WV ACE Partial State Plan
Appendix E
Public Participation

Re: West Virginia CAA § 111(d) Partial Plan for
Greenhouse Gas Emissions from Existing Electric
Utility Generating Units (EGUs)

**West Virginia CAA §111(d) Partial Plan for Greenhouse Gas Emissions from Existing
Electric Utility Generating Units (EGUs)
RESPONSE TO COMMENTS**

Figure One. Longview Rolling Annual Average Emission Rates¹

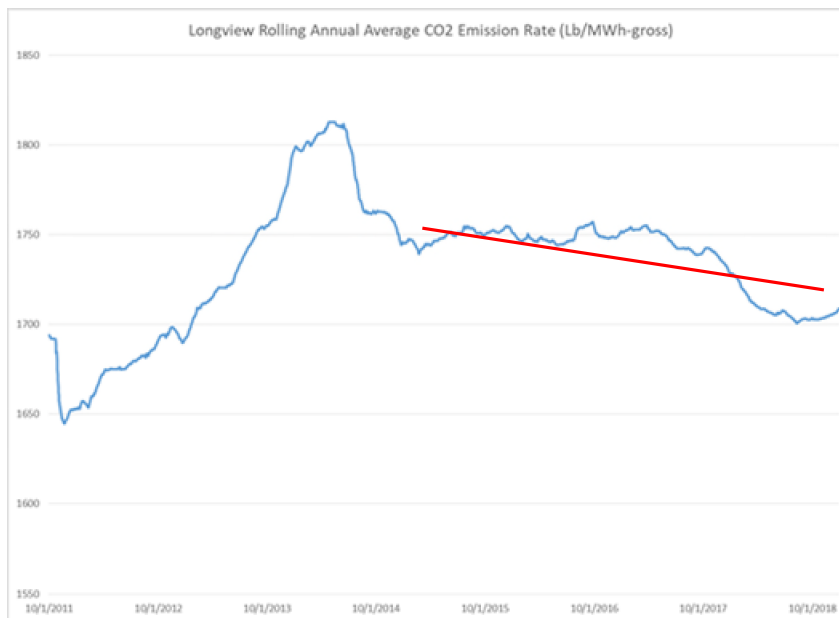
2) The inclusion of a Unit Degradation Adjustment Factor (page 11 of the Partial Plan) is based on the assumption of degraded performance as the plant ages (Table 4.4.b.3 of the Partial Plan), yet this assumption is contrary to observed facts. Longview’s own data (See Figure One, below) also show that, after initial startup issues were resolved, the emission rate improved over time (as some – but by no means all - of the recommended HRI technologies were adopted)

rather than degrading. It should also be understood that these rates include operation in all Load Bins and were achieved at a time when Longview's operator was under no obligation to maintain a specific emission limitation and may have found it to be economically rewarding to operate in a fuel-inefficient manner. Thus, instead of seeking improvements in performance and reductions in emissions, the proposed limits in the draft Partial Plan would allow significant increases in greenhouse gas emissions. **Including emissions rates and UDAFs for plants that have not implemented the needed O&M is inappropriate.** The UDAF also allows the emissions rate increases to compound year-over-year, thus allowing much larger annual increases in later years. There does not appear to be any evidence to justify this, where it does occur, it shows a linear, not logarithmic, increase (even in plants not required to implement Heat Rate Improvements). **Since the goal is to limit greenhouse gas emissions, we recommend that the Partial Plan use lower rates for UDAF, provide better justification for any non-zero UDAF, and apply them only to the base year, rather than using a compound interest approach as currently proposed.**

Figure One. Longview Rolling Annual Average Emission Rates¹

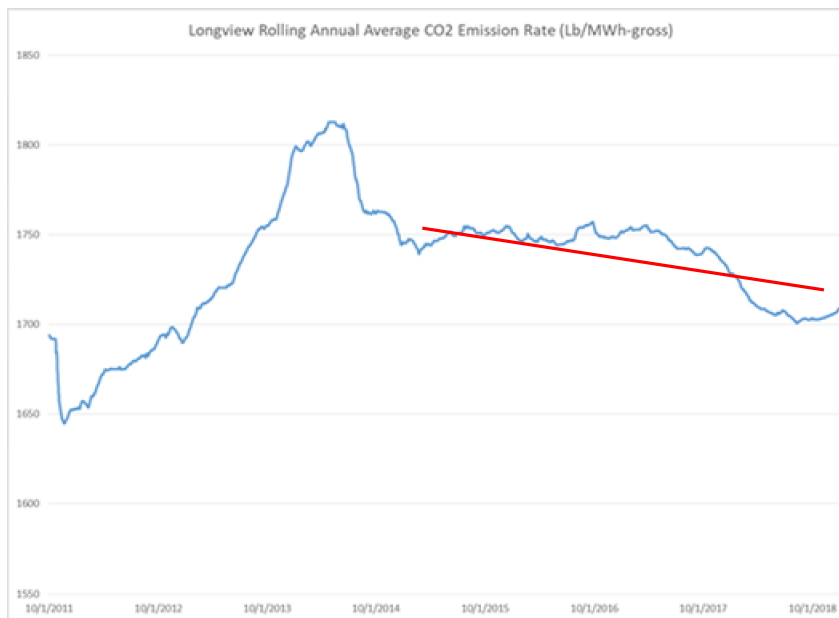
2) The inclusion of a Unit Degradation Adjustment Factor (page 11 of the Partial Plan) is based on the assumption of degraded performance as the plant ages (Table 4.4.b.3 of the Partial Plan), yet this assumption is contrary to observed facts. Longview’s own data (See Figure One, below) also show that, after initial startup issues were resolved, the emission rate improved over time (as some – but by no means all - of the recommended HRI technologies were adopted)

rather than degrading. It should also be understood that these rates include operation in all Load Bins and were achieved at a time when Longview's operator was under no obligation to maintain a specific emission limitation and may have found it to be economically rewarding to operate in a fuel-inefficient manner. Thus, instead of seeking improvements in performance and reductions in emissions, the proposed limits in the draft Partial Plan would allow significant increases in greenhouse gas emissions. **Including emissions rates and UDAFs for plants that have not implemented the needed O&M is inappropriate.** The UDAF also allows the emissions rate increases to compound year-over-year, thus allowing much larger annual increases in later years. There does not appear to be any evidence to justify this, where it does occur, it shows a linear, not logarithmic, increase (even in plants not required to implement Heat Rate Improvements). **Since the goal is to limit greenhouse gas emissions, we recommend that the Partial Plan use lower rates for UDAF, provide better justification for any non-zero UDAF, and apply them only to the base year, rather than using a compound interest approach as currently proposed.**
